OBJECTION TO SITE SN0433 – VCHAP CONSULTATION ENDING 05/02/2024

(document consisting of pages 1 to 4 & plans 1 to 3)

PLAN 1

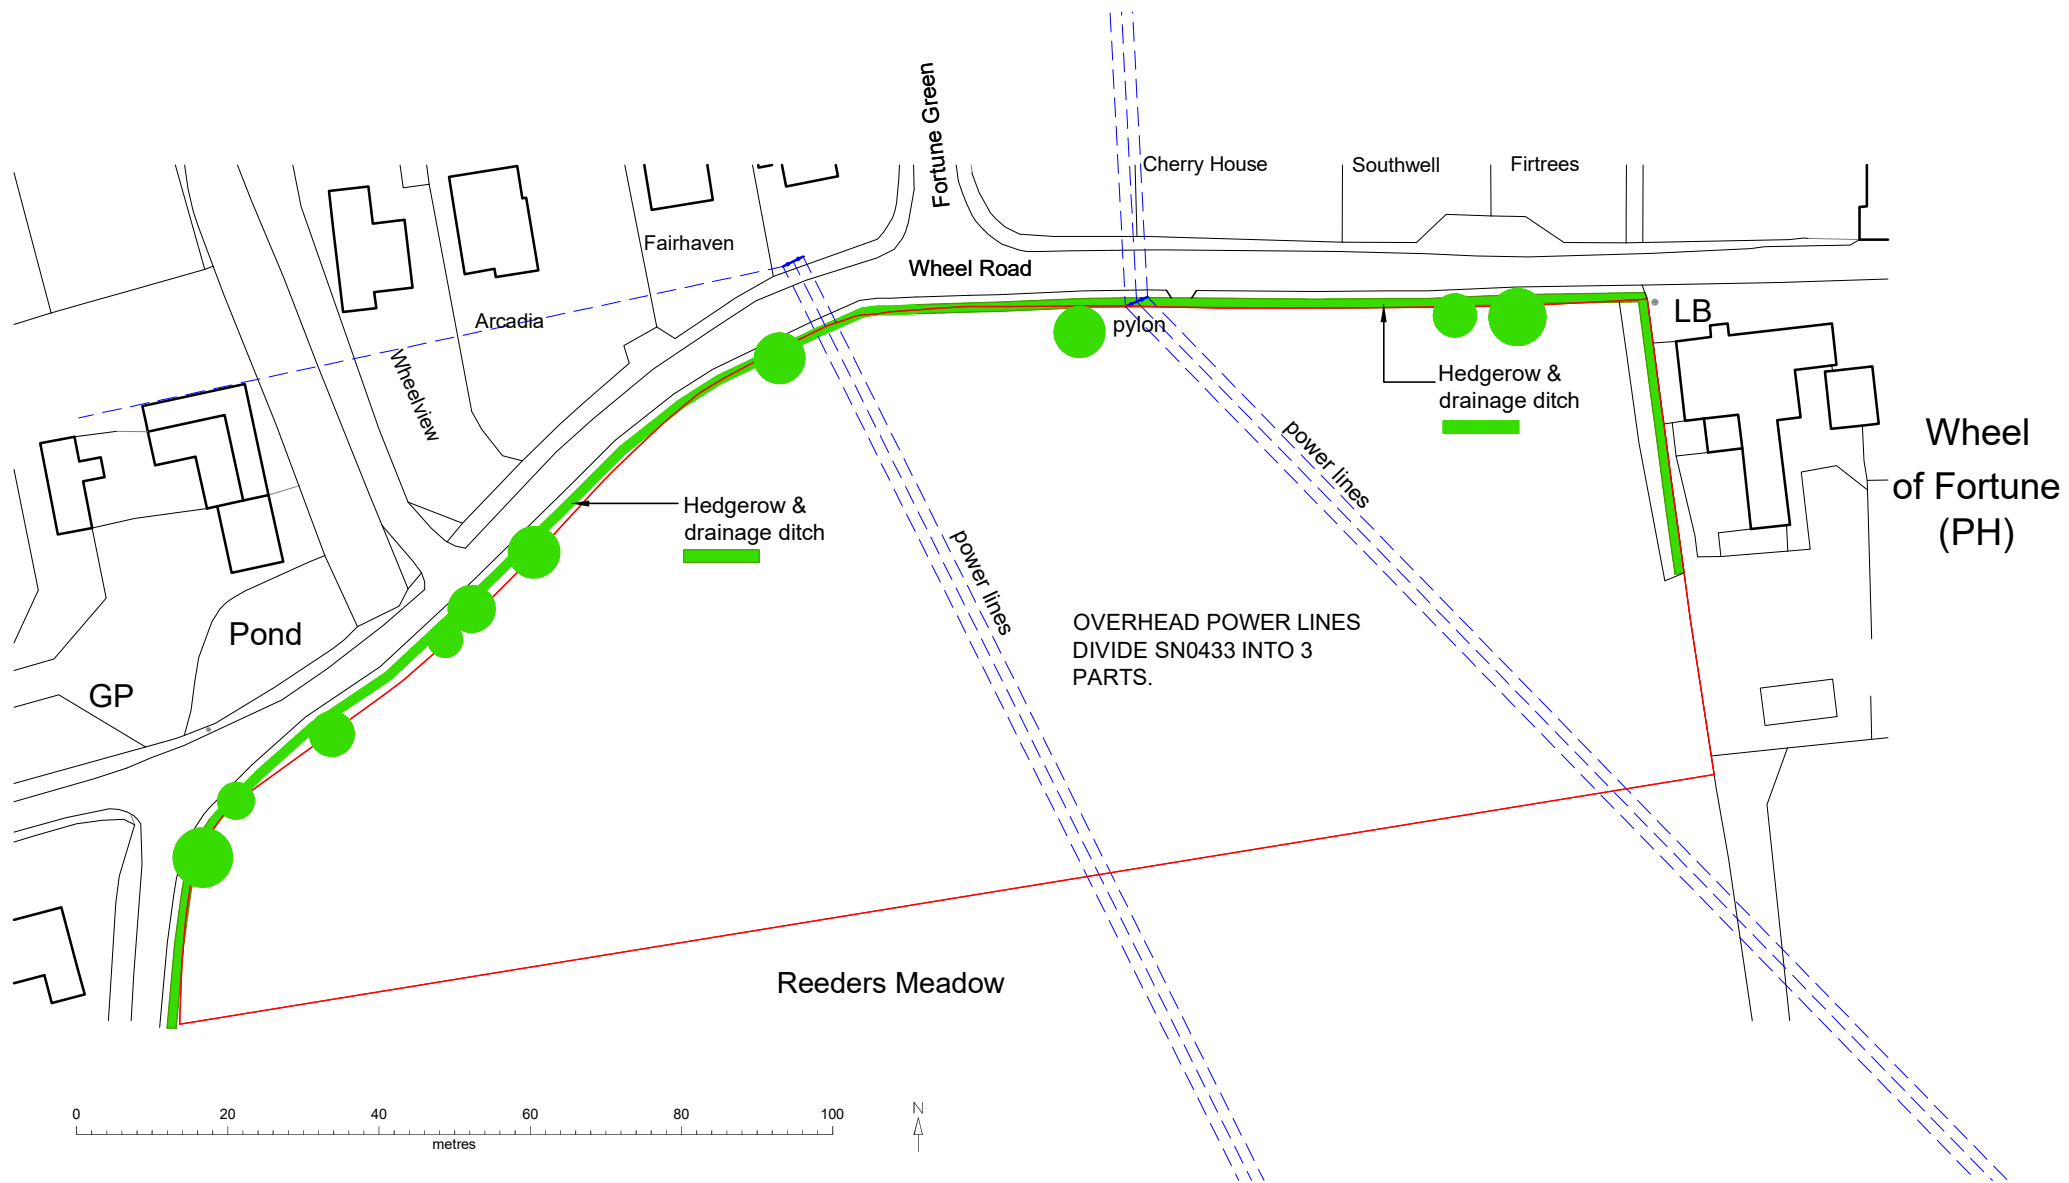
Despite this "need" having been identified, the feasibility of constructing dwellings in close proximity to the lines has not been investigated by the site promoter and there is no certainty that SN0433 is deliverable, this is a fundamental gap in demonstrating deliverability. **Plan 1** shows the approximate route of the lines and the pylon position, the lines divide the site into 3 parts.

PLAN 2

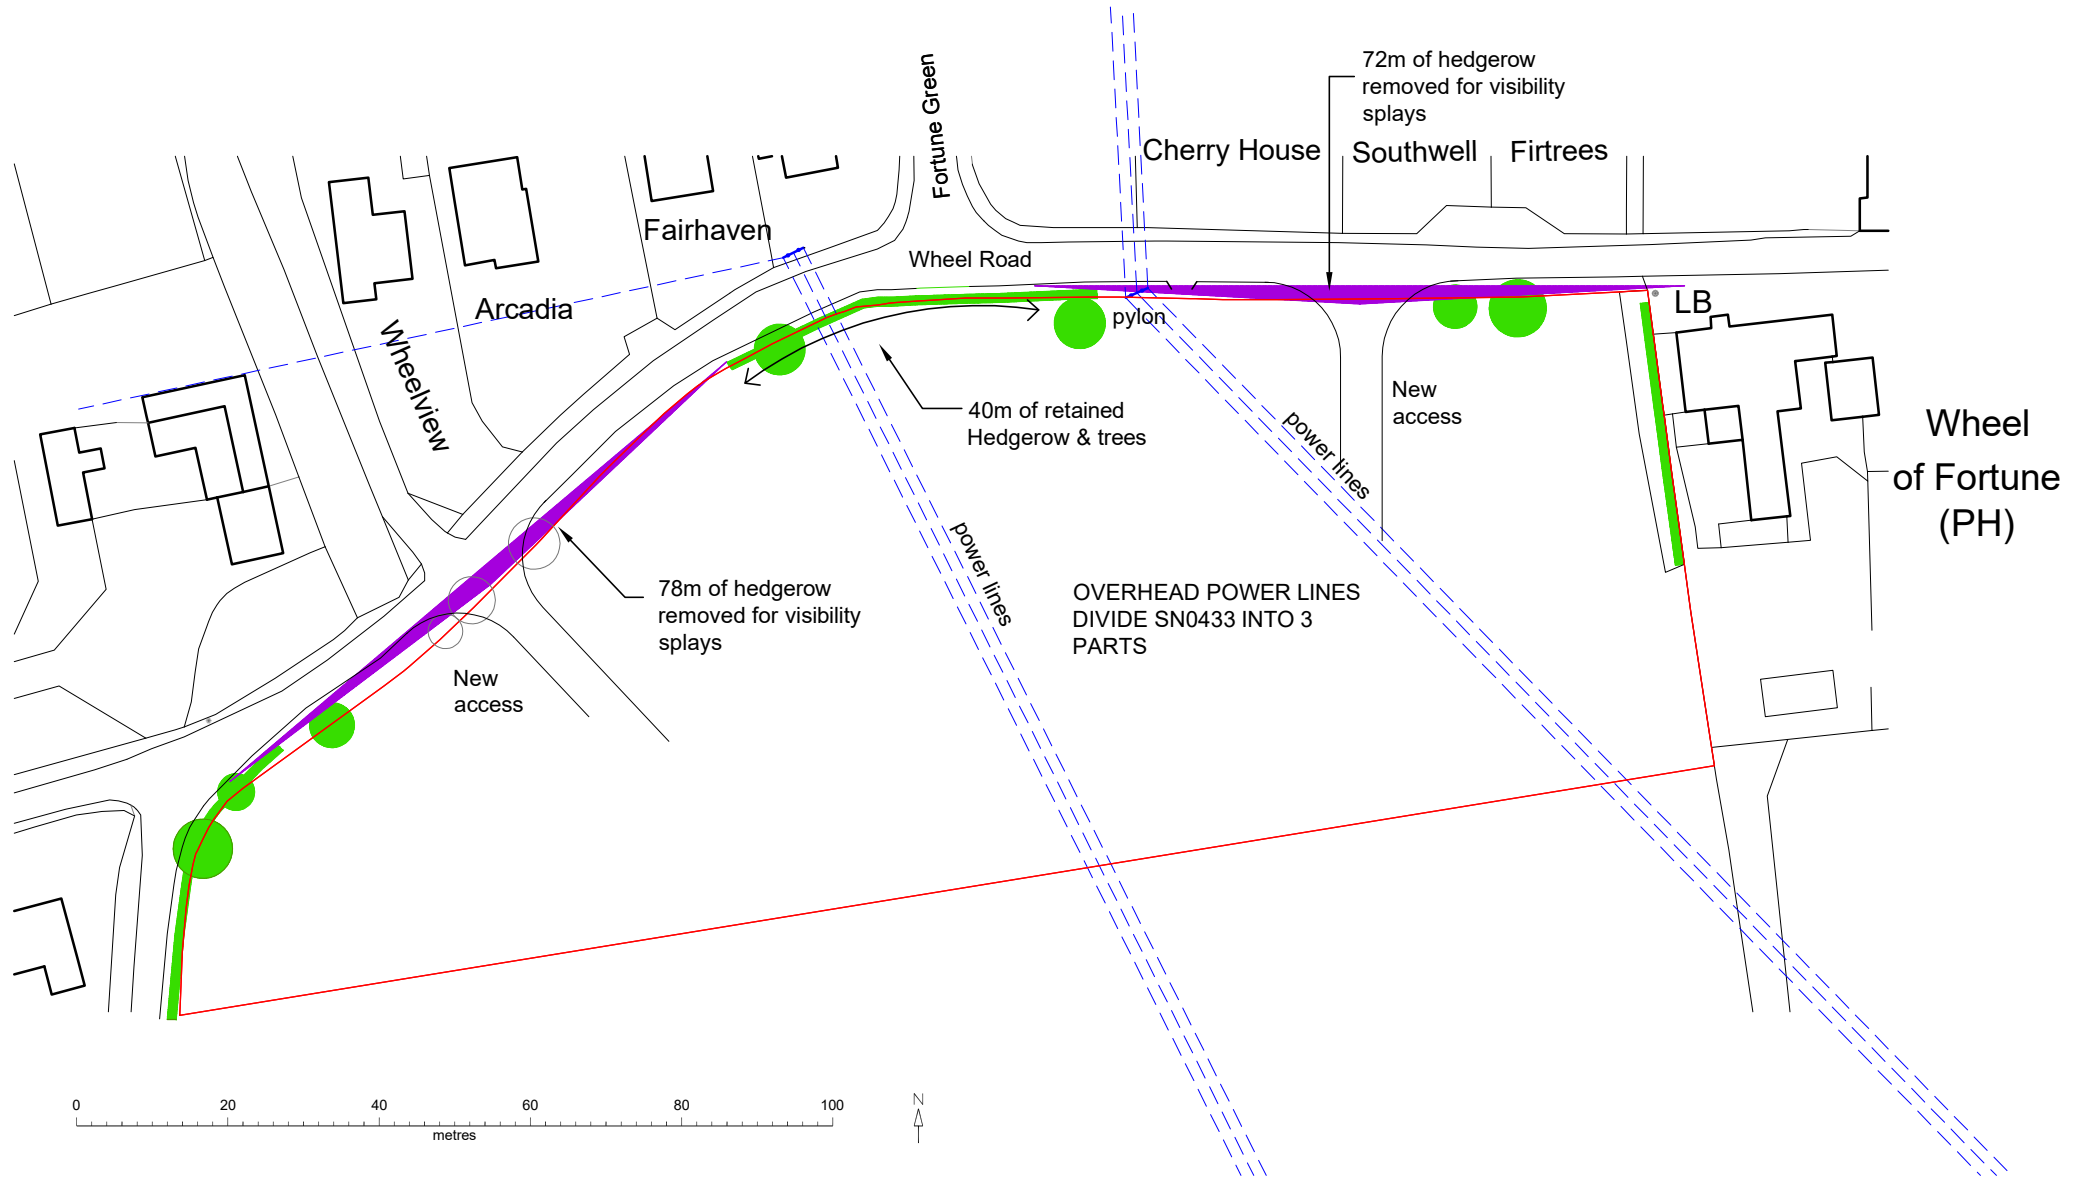
1.2 The principle of achieving a suitable access to SN0433 has never been established. The resultant impact on the historic hedgerow is that only approximately 22% will remain (**Plan 2**) this constitutes it's "removal". Replacement hedging can be no higher than 60cm, neither replacing the visual screening nor the biodiversity of the historic hedgerow. The reduced scale scheme still retains all the impact of significant change to the character of the area and the landscape character that led to the 25 dwelling scheme being discounted. SN0433 will appear as a suburban sprawl where once was countryside.

1.7 **Plan 2** appended to this document, plots the visibility sight lines. I have made the assumption that 2 access points are required to achieve the required site density. This is reasonable as 2 access points served the 10 dwelling scheme to the East by the same site promoted. The site promoter has actually verified that 2 access points are intended in their own consultation comment. It is reasonable to assume the 2 access points will be some distance apart or their purpose to distribute traffic is not served, I have placed a site access on each of the 2 straighter sections of road as highways would require.

1.8 The resultant impact on the hedgerow is that only 22% will remain, constituting it's “removal” . All the concerns remain of significant change to the character of the area and the landscape character, these concerns resulted in the 25 dwelling scheme being discounted. I direct the reader to Taylor Wimpey's objection document prepared by James Bailey Planning that further substantiates why in this situation SN0433 must be discounted.

PLAN 3

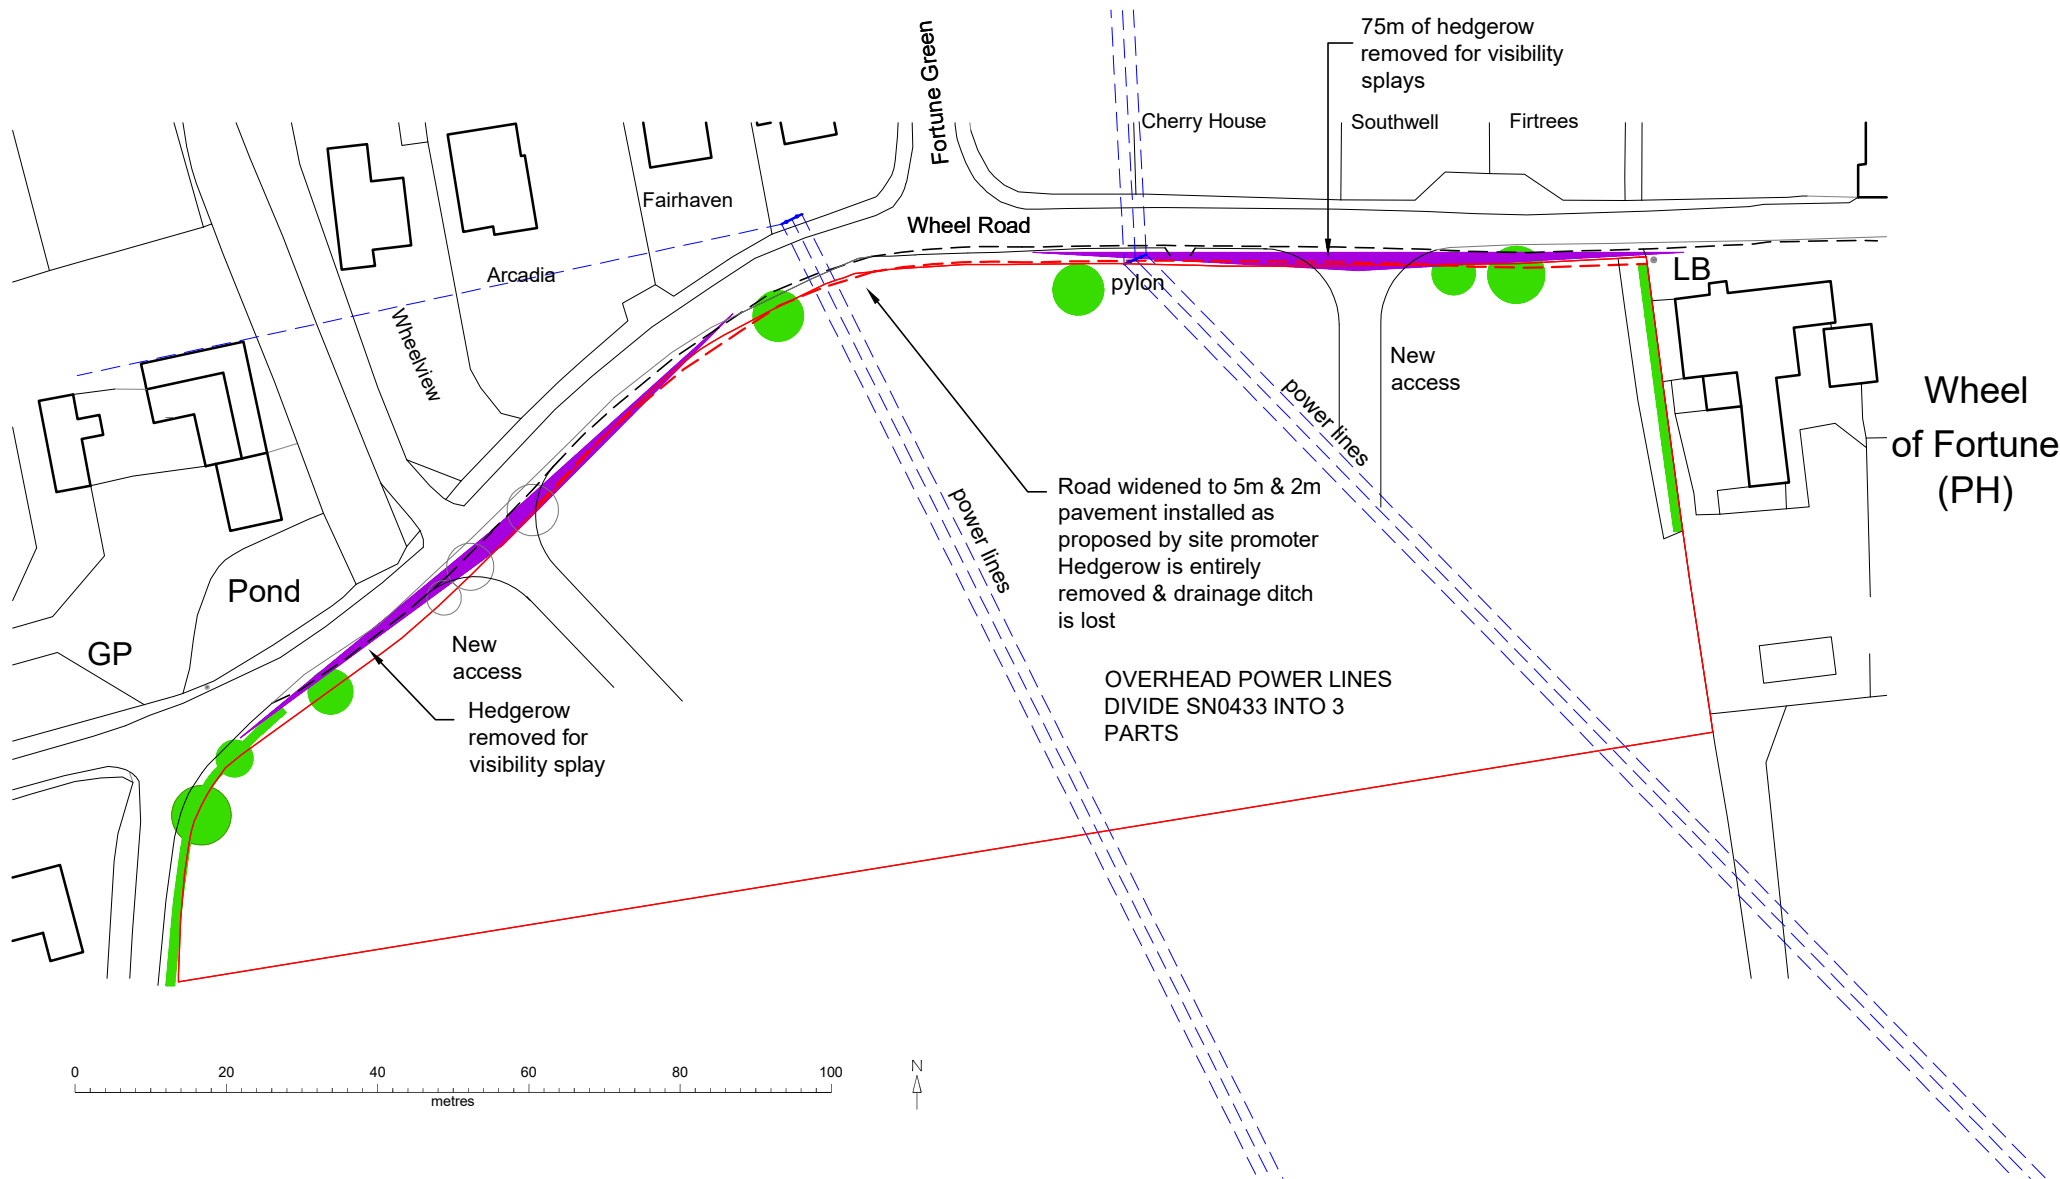
2.1 The site promoter's stated intention is to widen the road and to provide a 2m wide footpath, this will result in the hedgerow being removed and drainage ditch disrupted, as shown on **Plan 3**. The larger 25 dwelling scheme was discounted on this very basis. SN0433 is not deliverable on this basis.

3.2 A field drainage ditch, runs between Wheel Road and the Hedgerow, it has not been acknowledged in the site assessments. The road widening and 2m pavement proposed by the site promoter will result in the loss of the ditch, the impact in principle of this has not been assessed. It is an anomaly that the site promoter makes no mention of this ditch despite conversely referring specifically to the retention of another much shorter ditch to the Eastern boundary alongside the Wheel Pub.
